NORTH MACADAM DISTRICT STREET PLAN IMPLEMENTATION AMENDMENTS

Ordinance No. 171522

**Amendments to: the Zoning Code, Willamette
Greenway Plan, and the Design Guidelines for the
North Macadam District of the Central City Plan**

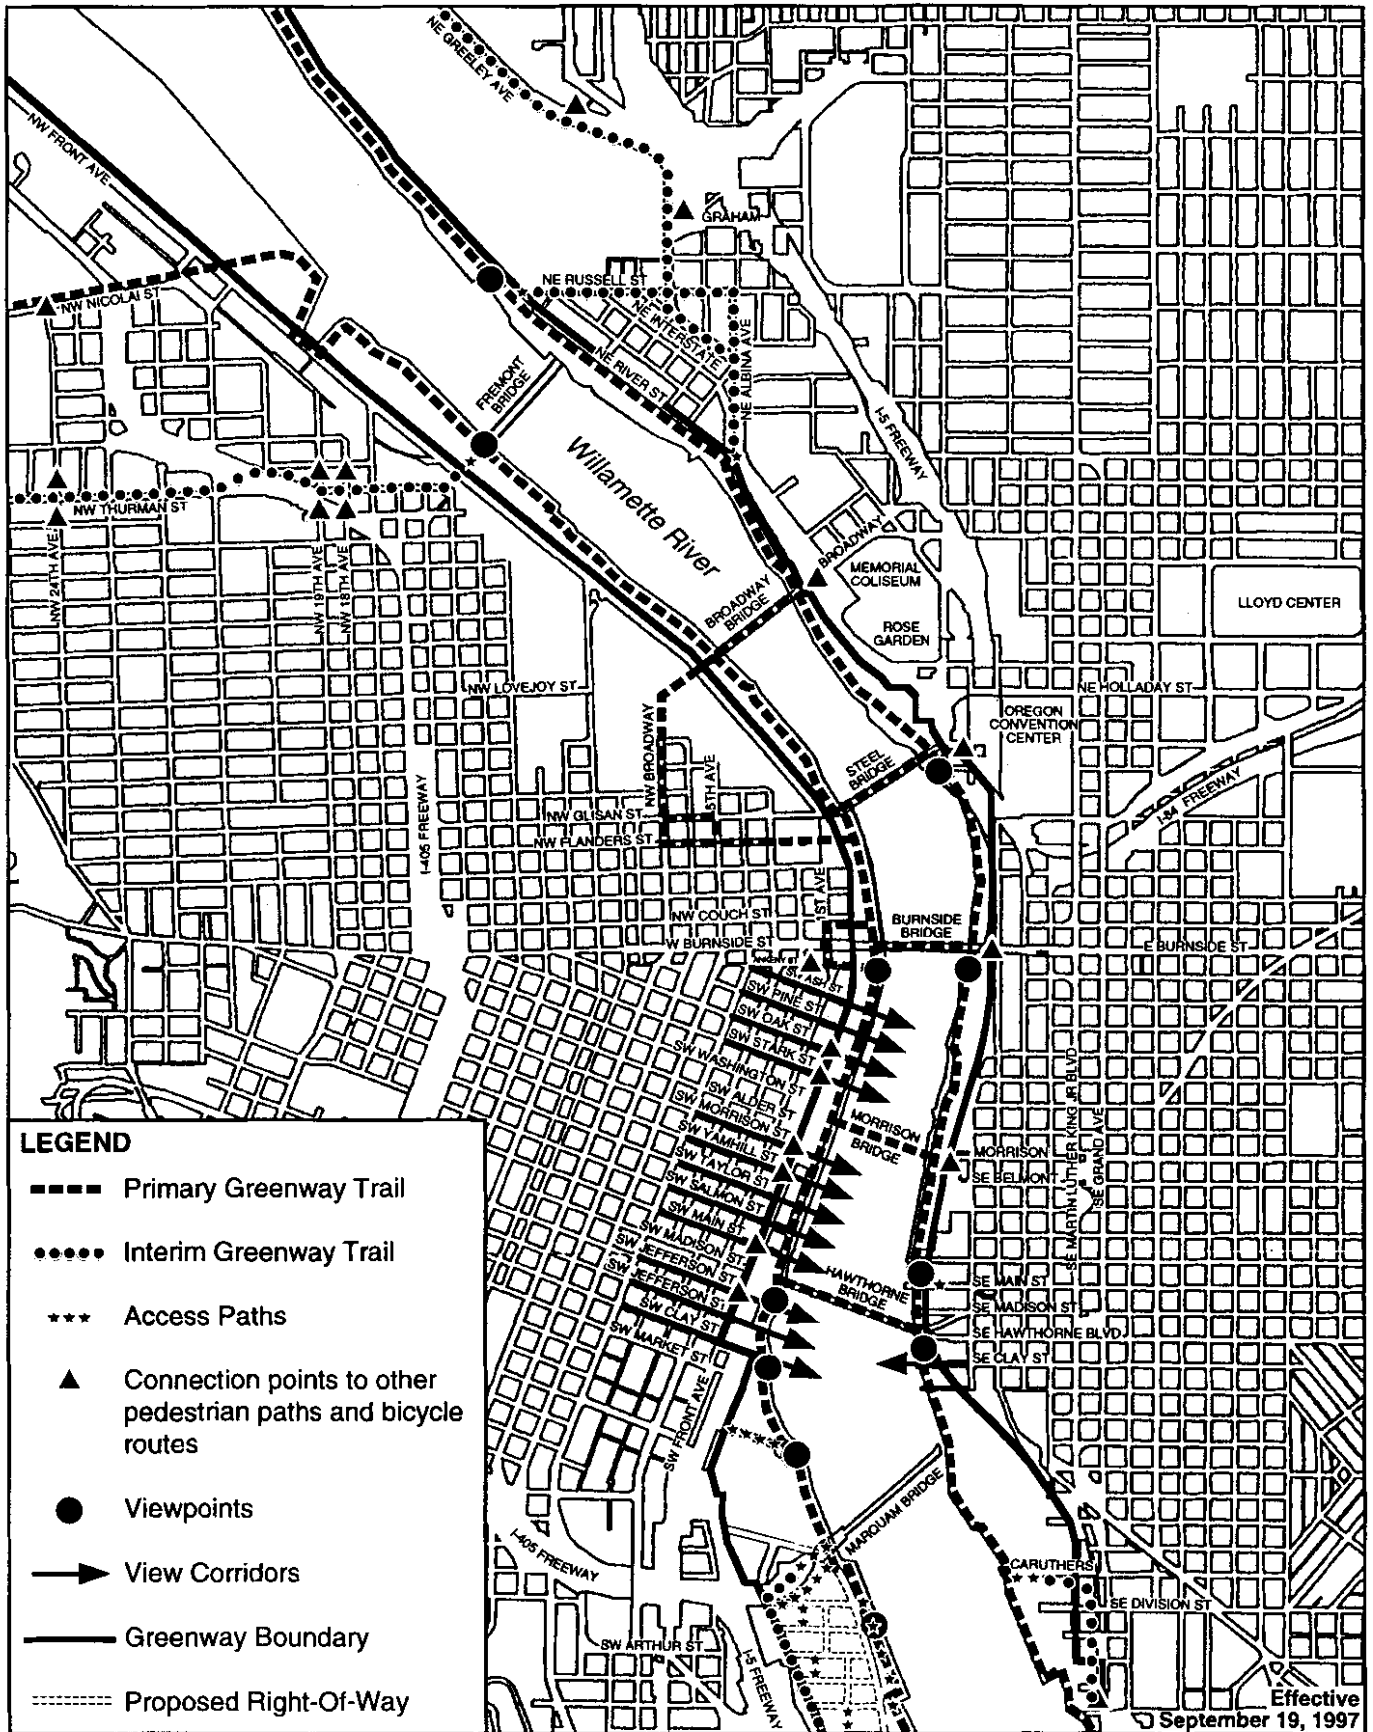
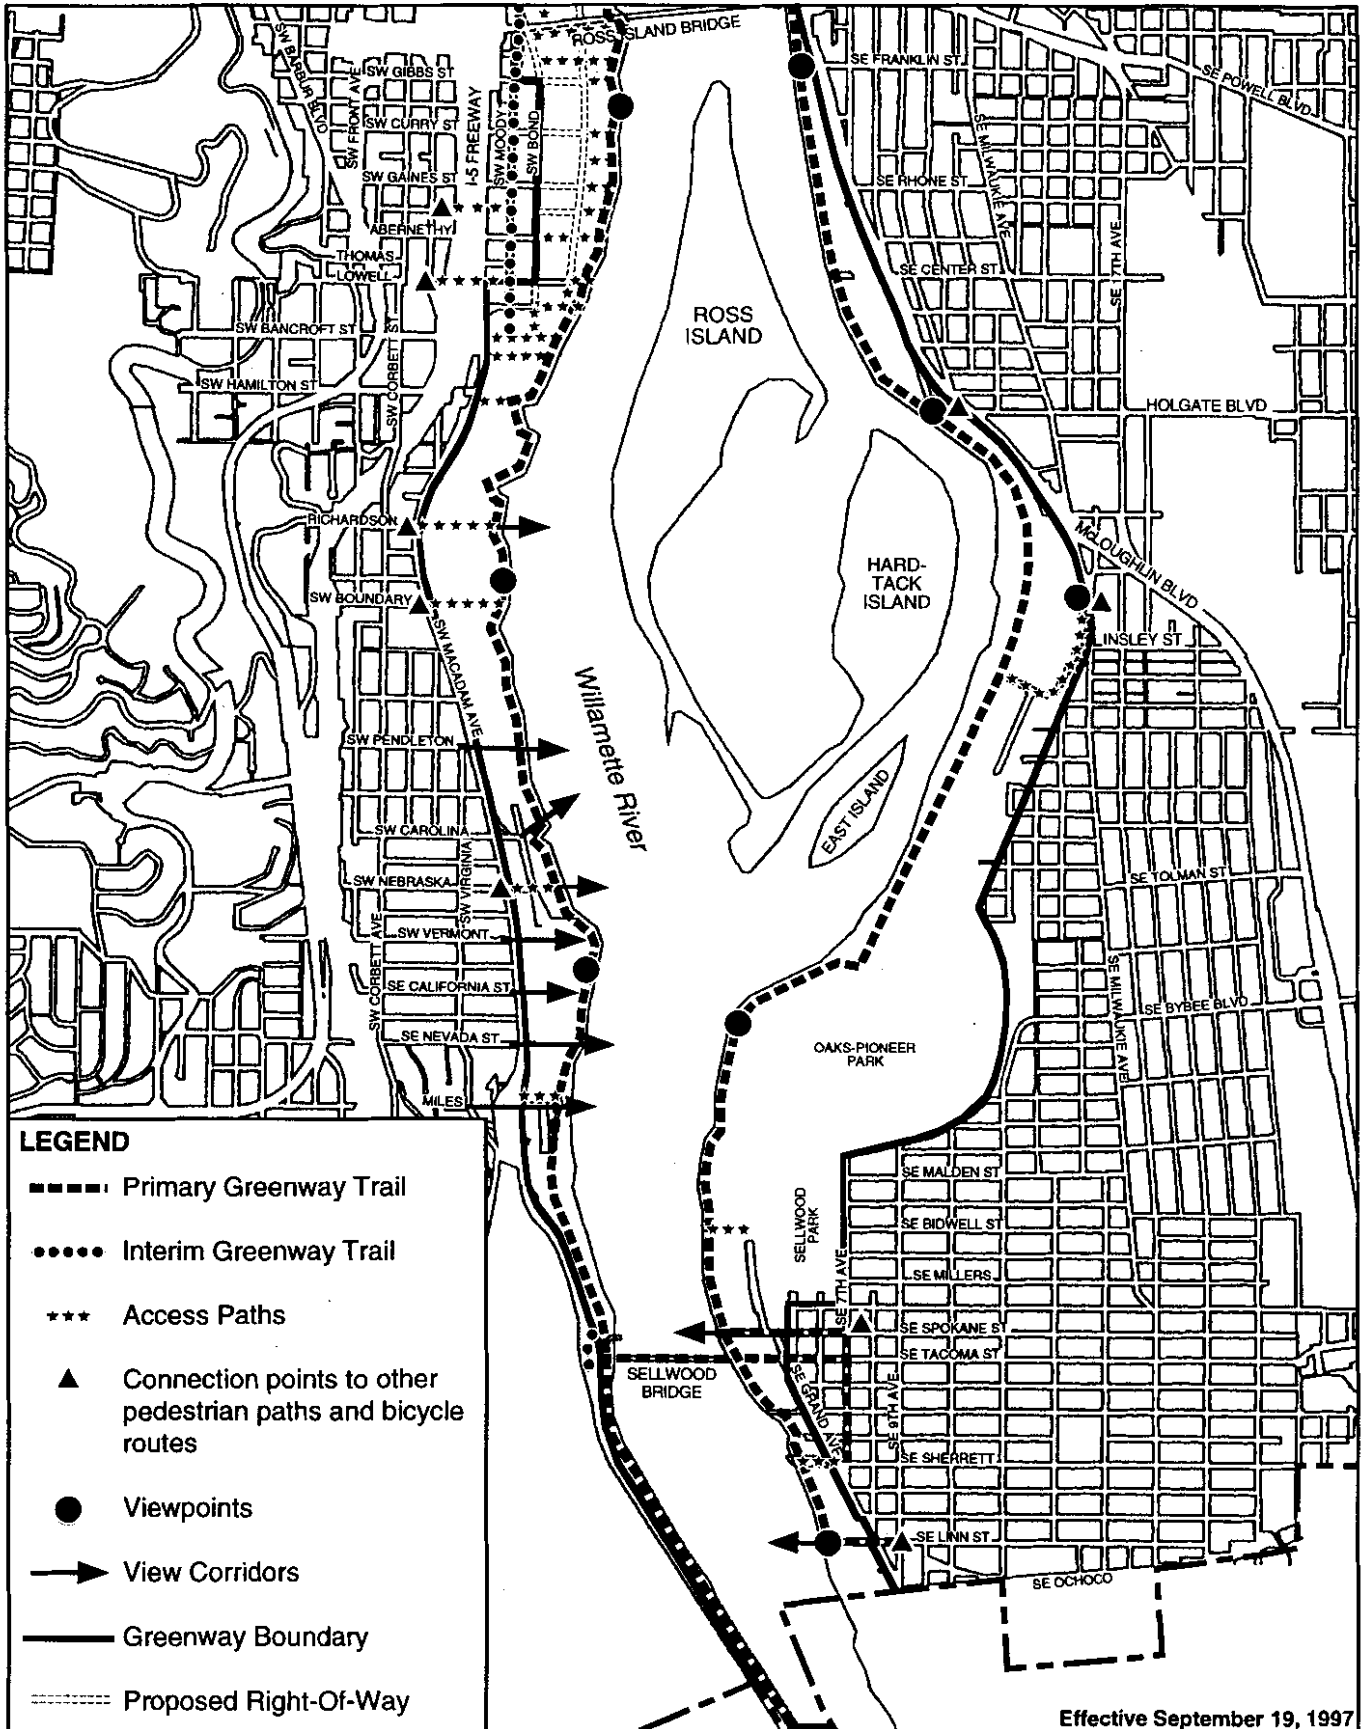
The North Macadam District Street Plan identifies 19 existing or future pedestrian-bicycle accessways to the Willamette Greenway. The south segment of the Willamette Greenway Plan Public Access Map has been revised as two GIS maps which note the planned accessways. This will make the Willamette Greenway Plan consistent with the North Macadam District Street Plan, the Special Design Guidelines for the North Macadam District of the Central City Plan and the Zoning Code.

SPECIAL DESIGN GUIDELINES for the NORTH MACADAM DISTRICT of the CENTRAL CITY PLAN

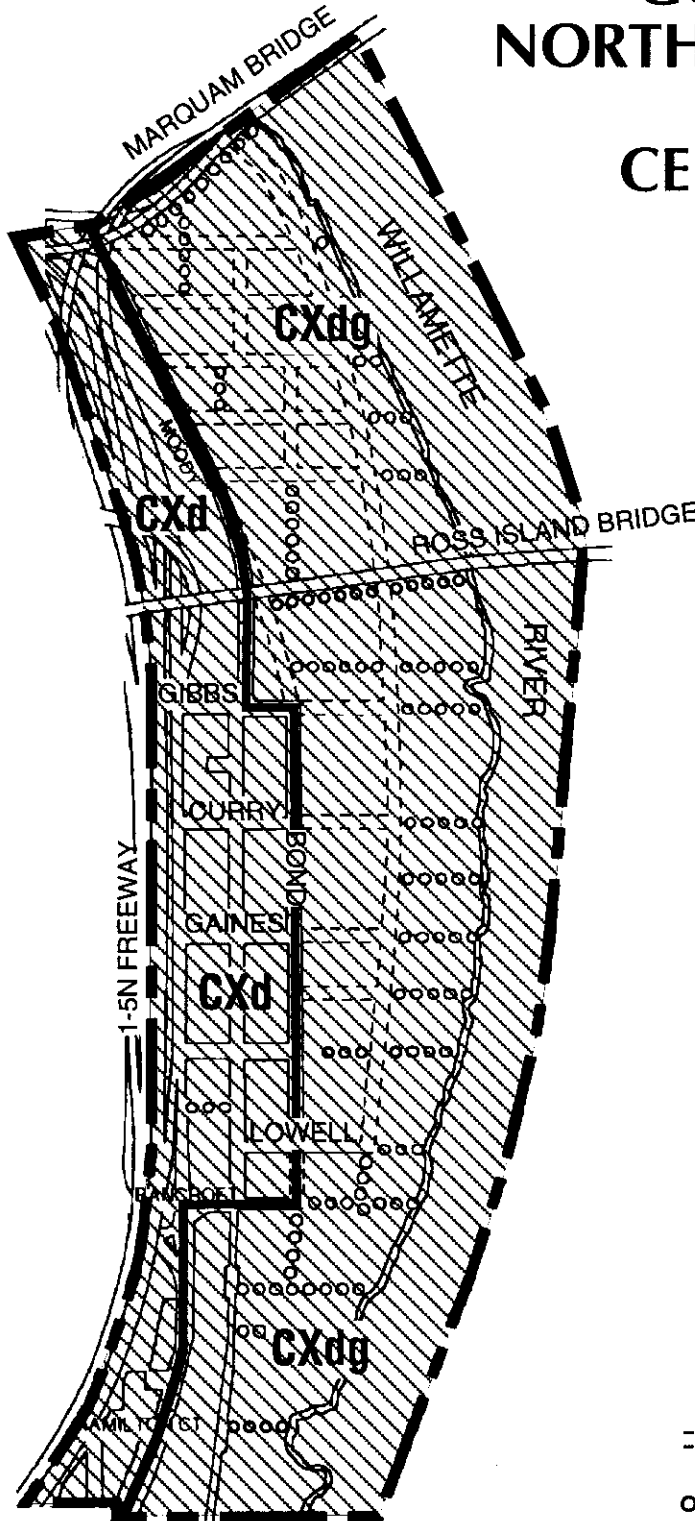
The Map for the North Macadam District of the Central City Plan that is contained in the Special Design Guidelines for the North Macadam District of the Central City Plan does not reflect the accepted Street Plan for the district. An updated map was adopted by City Council to include the revised street network for the North Macadam District.

Please note that there is differentiation between existing and future streets. There were no other changes made to this map.
